6758B **County Permit Review Worksheet** 1375

IMPROVEMENT PERMIT for a RESIDENTIAL ON-SITE WASTEWATER TREATMENT & DISPOSAL SYSTEM

GWS Septic System Design Review

RE: Request for an Improvement Permit for Lot 20 off of Sample Road.
MCHD File #6758B

Scale: 1 inch equals 50 feet	S&ME	Faison - Sample Road LLC	FIGURE
Drawn by: JBP		Lot 20	1
Reviewed by: TCJ		Mecklenburg County, NC	
Date: June, 2007	ENVIRONMENTAL SERVICES • ENGINEERING • TESTING	S&ME Project #1588-05-091

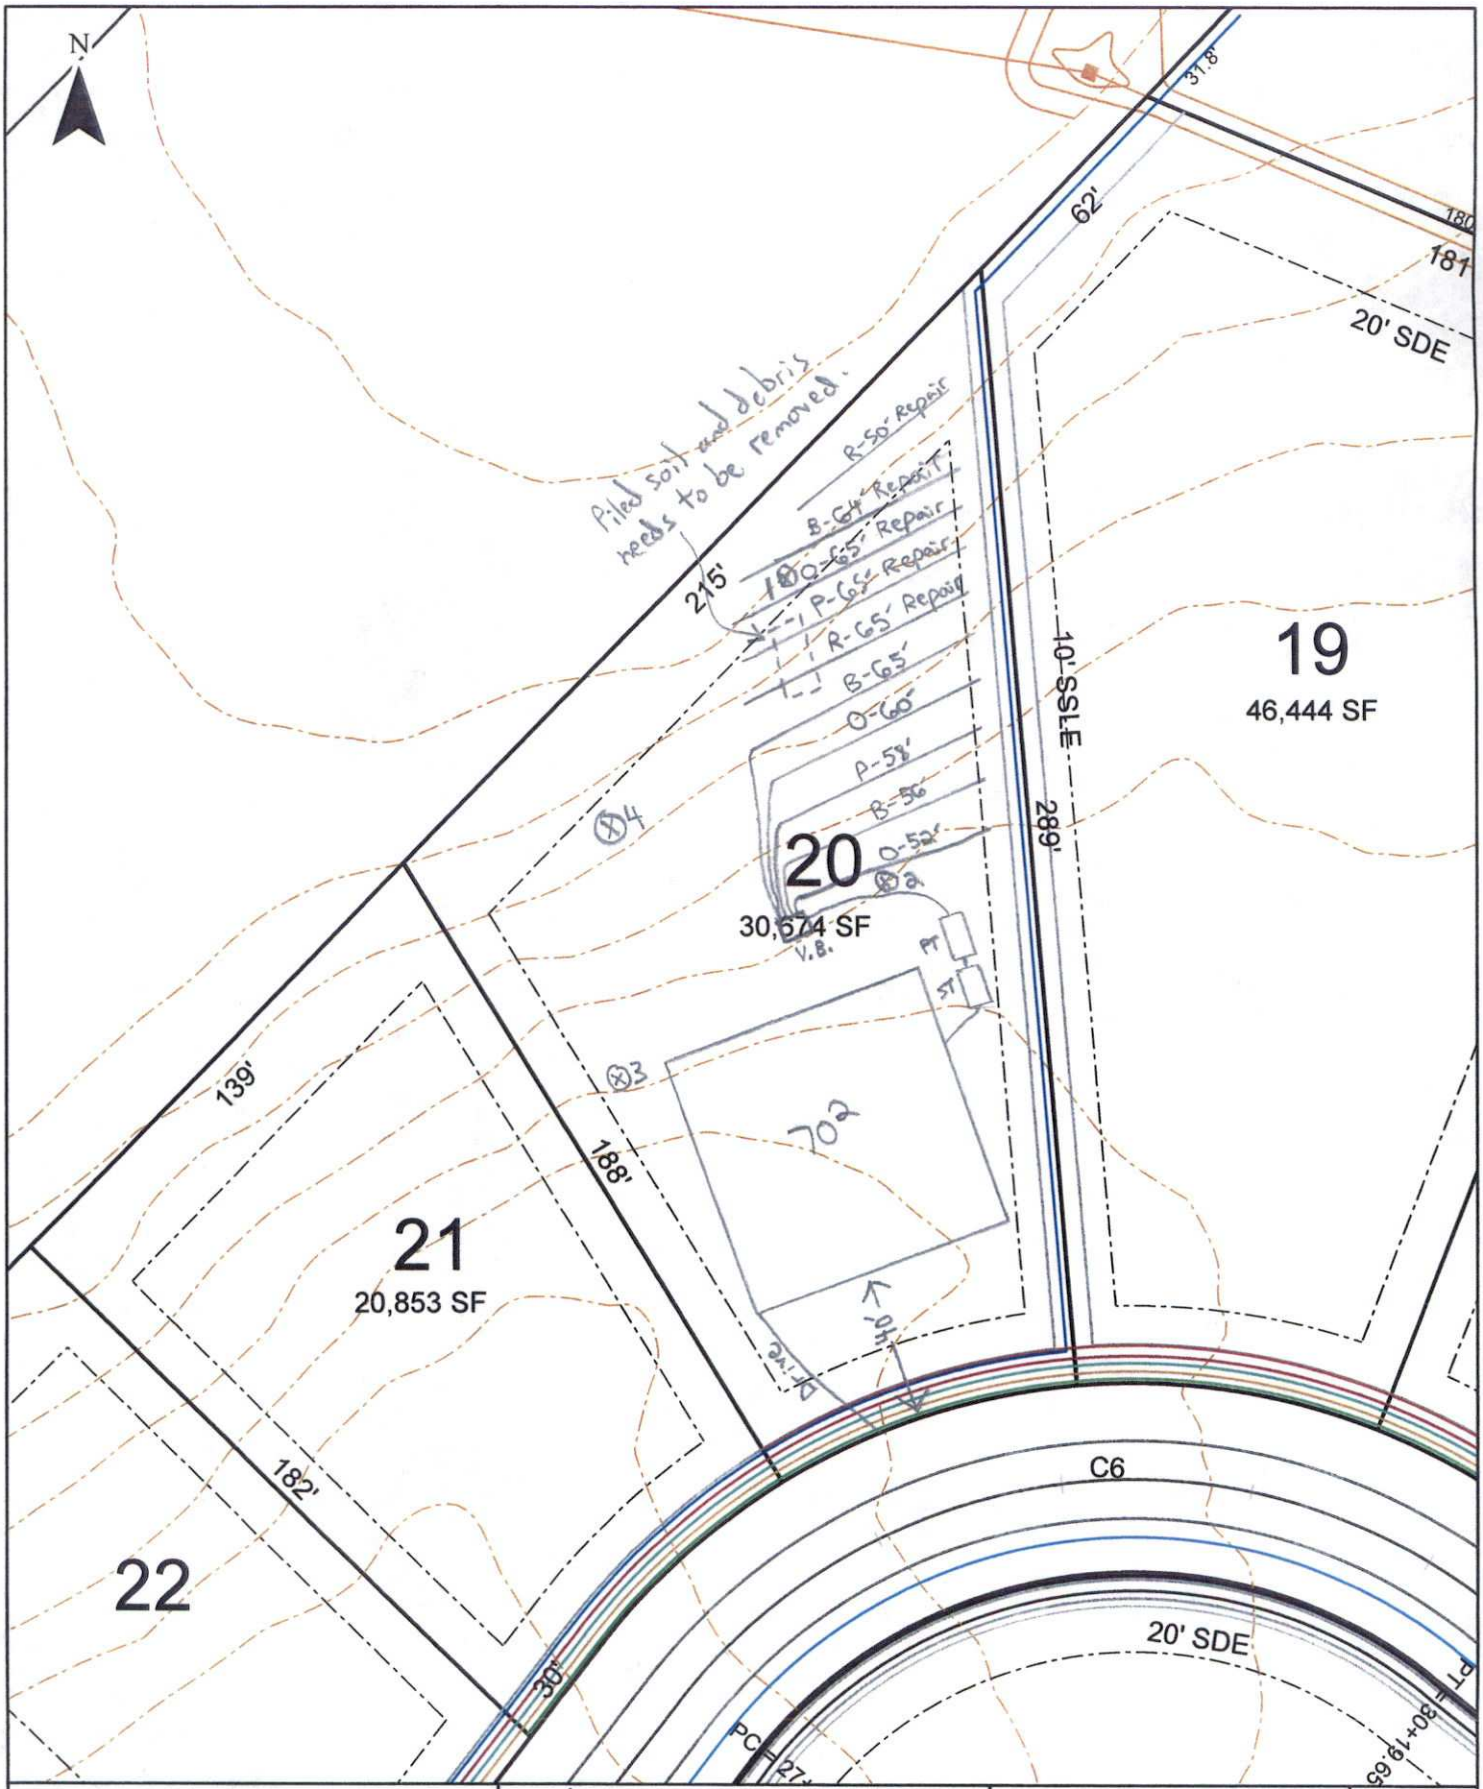
Notes: Before placement of cap block, one panel on each line, near the center of the field should be observed filling to make certain that it does not overflow the top chamber into the air chambers. If overflow occurs, reduce floats by 25 gallons and reset until no overflow is observed.

1. Install system using 3 ft. wide trenches.								
2. Install drainlines on 9 ft. centers, level, and on contour.								
3. System design requires effluent pump for distribution.

4. 100% Repair area is required.

GWS File #: 6758B	**Approved**	**Disapproved**
Design Review: TCT 6-18-07	☒	☐
Field Review: 6/14/07	☒	☐
